To All US and Canadian Lamborghini Dealers and Licensed Service Points
From Customer Service Department
Subject Repositioning of the SDARS antenna
Group 824.0.35
Date 25.11.2008
Pages 5

Repositioning of the SDARS antenna.

All Murcielago LP 640 Coupès and Roadsters.
From VIN B93254 to VIN B83392 inclusive.

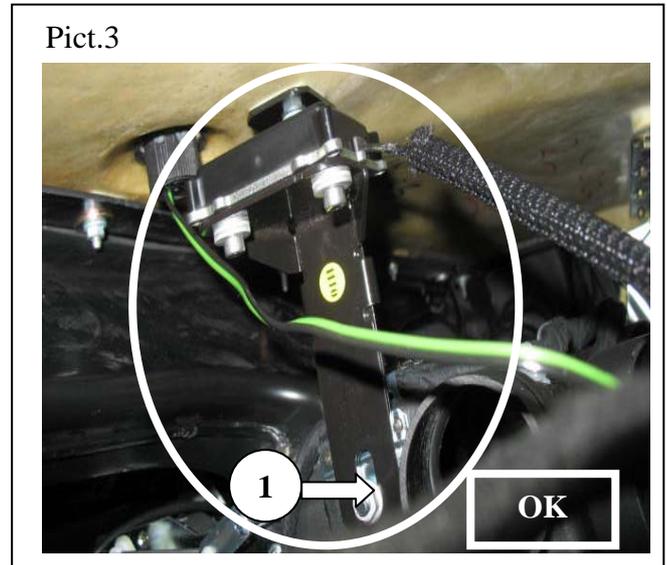
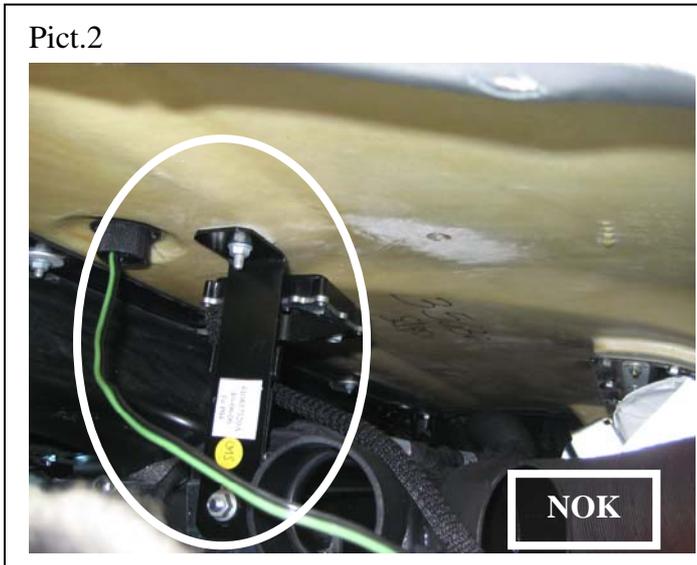
1.4 Check the position of the SDARS antenna: incorrect (Pict.2) or correct (Pict.3).

1.5 If the SDARS antenna is in the wrong position (Pict.2), unscrew the bolt (1-Pict.3) and remove the bracket with SDARS antenna (1-Pict.4).

- 1.6** The plate of the bracket with the SDARS antenna must to be positioned in front of the GFA ECU (see also the Pict. 3 and 4).
